UAT-WP26-07R1
11 – 13 August 2009

RTCA Special Committee 186, Working Group 5

ADS-B UAT MOPS Maintenance

Proposed Changes to Appendix K
In Response to Action Item 25-03
Revision 1

Figure K-131: Typical Result for Scenario 3 for Update Interval as a Function of Bank Angle

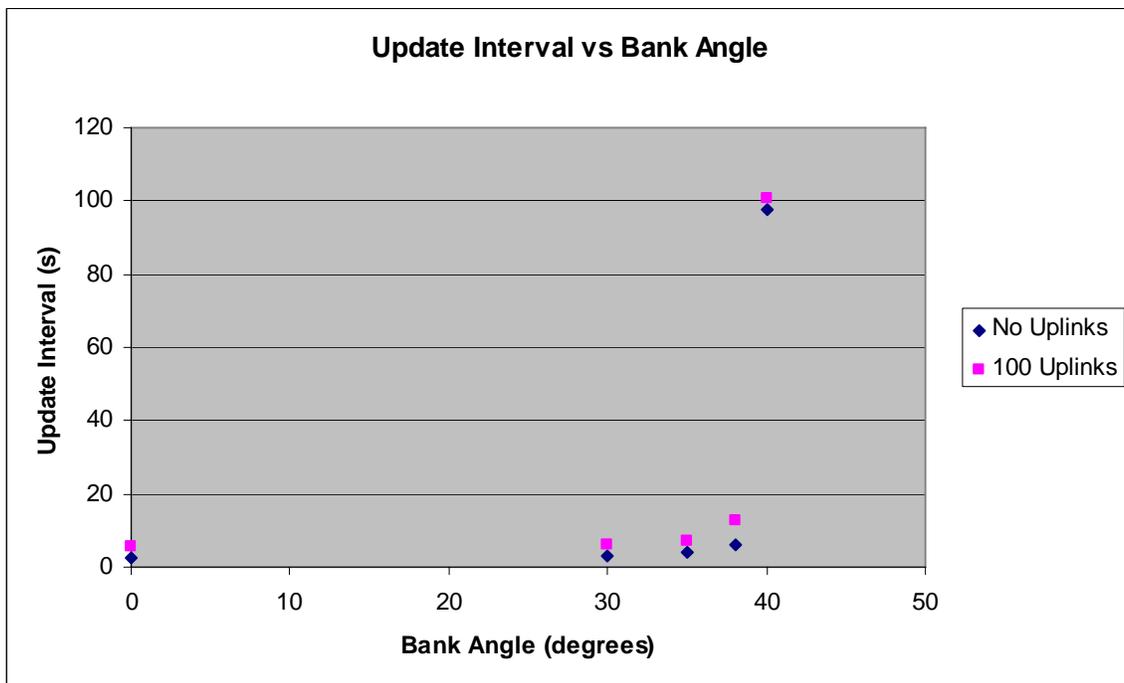
For all ranges, the A1S achieved a 95% update interval less than three seconds (3 seconds is required in the terminal domain) with no bank angle and no ground uplinks. Adding 100 ground uplinks resulted in an increase in the 95% update interval to around 5 seconds at 10 NM and around 6 seconds at 50 NM. Increasing the bank angle resulted in a gradual increase in update interval up to a critical angle, where the curve experiences a sharp rise (see figure below). The critical angle varies with

the range from the receive antenna: a greater range corresponds to a smaller critical angle.

Note that the critical angle for the case in Figure K-131 is around 40 degrees. Also, the effect of the addition of 100 uplink transmissions is shown.
